ListExecute Qbv StateMachine

Tick and Clock Topics. 60802 Sys Req Input

Thomas Enzinger, Marius Stanica, Rodney Cummings, Jordon Woods

Figure 8-15—List Execute state machine

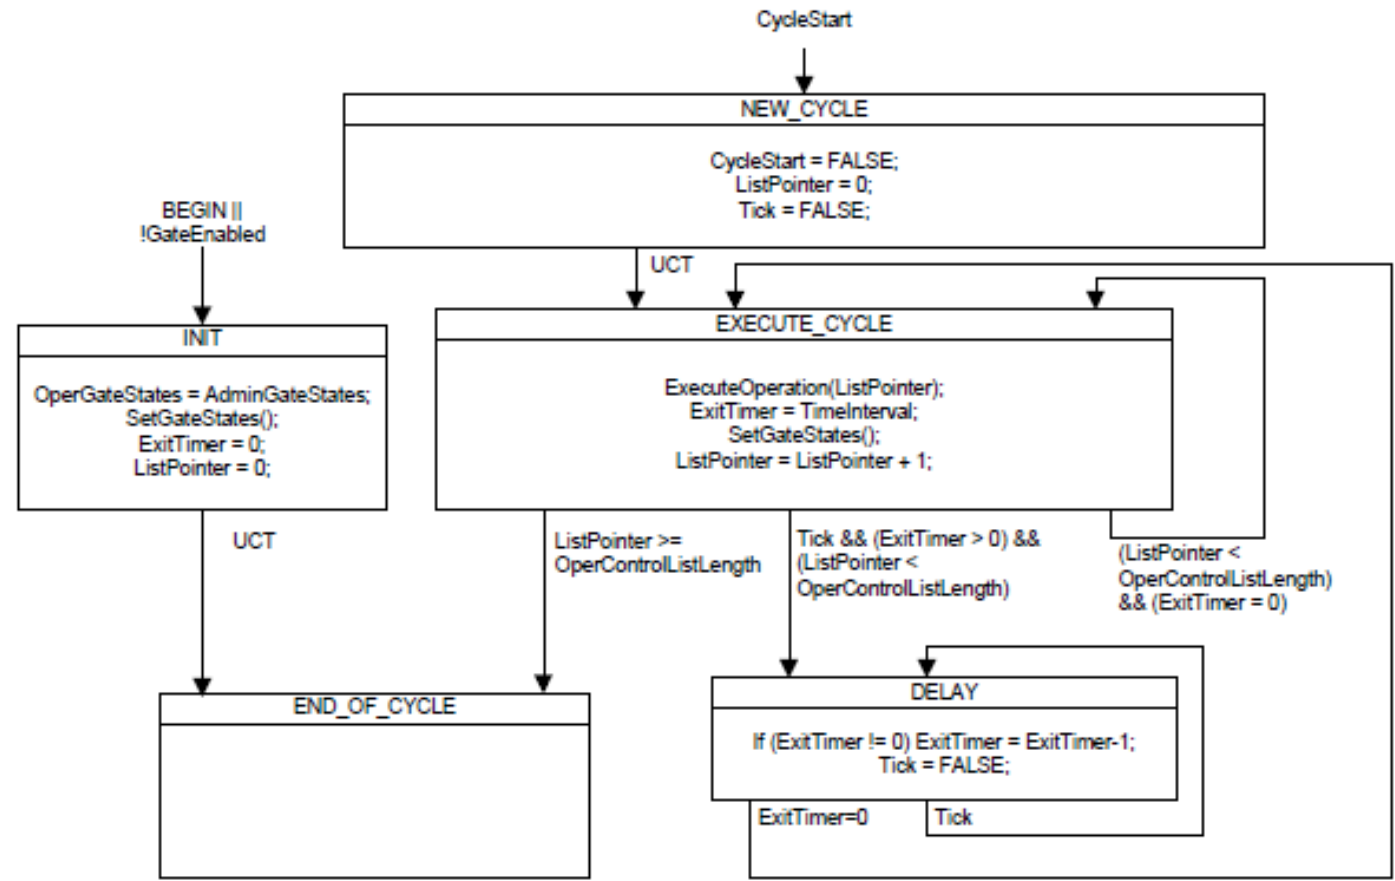
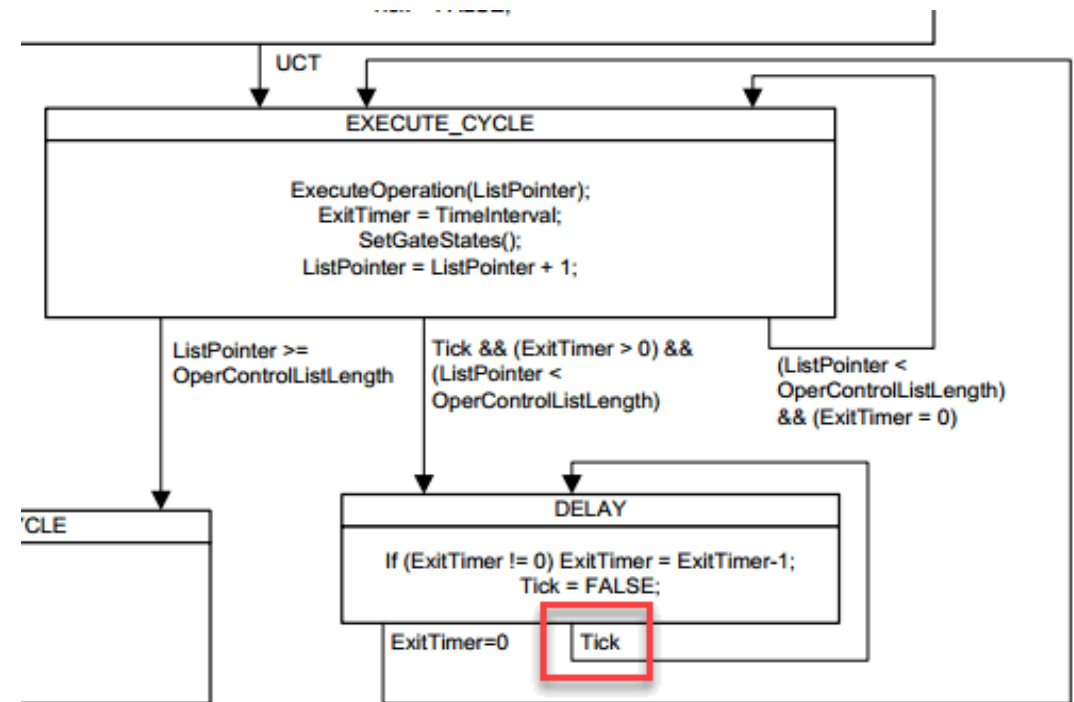
- EXECUTE_CYCLE state start is driven by the synchronized clock distributed i.e. over 802.1AS mechanisms but the Tick driving various events within the cycle, it is driven by an implementation-specific system clock
- **So:** there is no explicit mechanism specified, ensuring that events happening within the gating cycle are not driven by the local clock of a device, which could be imprecise/depending on the quartz quality

- SetGateStates() operations cannot surely be driven by the 802.1AS clock, whilst the Tick is not driven by the 802.1AS clock (see definition 8.6.9.4.16)
- Thus: 2 devices with oscillator drifts of +/-100ppm and 1 event per each, scheduled at the end of a 10ms gating cycle, the execution of events would potentially be 2us apart from each other (scaling with the gating-cycle length)

- Interoperability issues may arise
- Proposal:
 - Let us have a system requirement in the JP 60802 System Requirements list so that we mandate the Tick to be driven by the 802.1AS synchronized clock
